SERVICE BULLETIN 51

SUBJECT: POSSIBLE NOSE GEAR DRAG BRACE BINDING

APPLICATION: Glasair III welded nose gear drag brace (363-5419-001).

FIGURE (1)

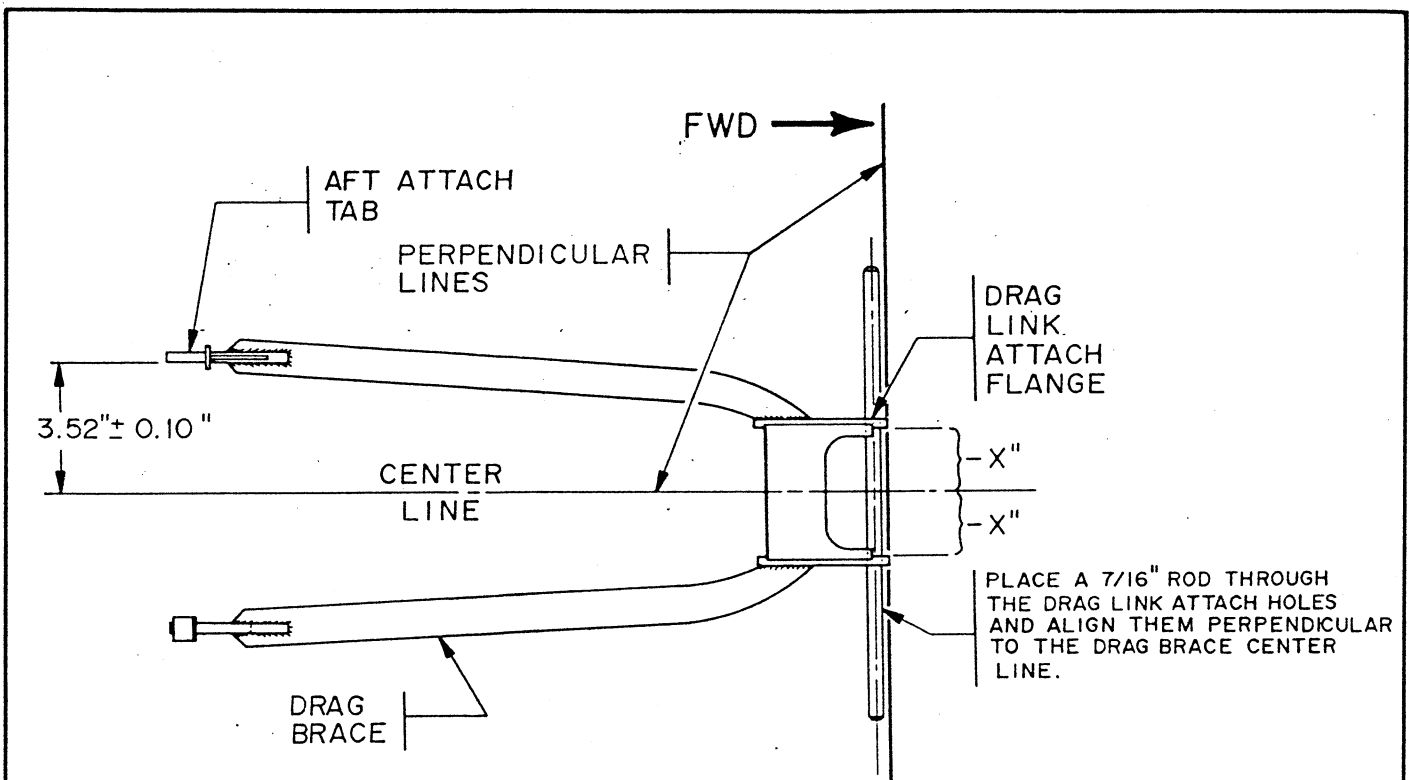
DESCRIPTION: During the fabrication of the first production run (50 assemblies) of the Glasair III nose gear drag brace, an unknown number of the drag braces were not jugged properly, resulting in the aft end of one (or both) drag brace tube(s) being an incorrect distance from the part centerline. This improper jugging of the drag brace could cause a binding or interference problem when retracting the nose gear.

SOLUTION: To determine whether your nose gear drag brace was jugged improperly, mark two perpendicular lines on a flat surface and insert a 7/16" rod through the drag link attach holes, as shown in FIGURE (1).

Center one of the perpendicular lines between the two drag link attach flanges, as shown, and align the forward edge of the 7/16" rod with the remaining line. Measure the distance between the center line (line running between the drag link attach flanges) and the drag brace aft attach tabs for both sides. The correct distance between the center line and the drag brace aft attach tab is 3.52" + or - 0.10".

If the drag brace supplied with your kit does not meet the dimensional requirements listed above, we request that the drag brace be returned to Stoddard-Hamilton Aircraft's shipping department by May 30, 1988. It is very important that Stoddard-Hamilton receive the dimensionally incorrect drag brace by this date, since we wish to adjust all incorrect drag brace assemblies at one time. Any parts returned after this deadline will not be corrected until the next production run of drag braces is fabricated (estimated time: 9 months).
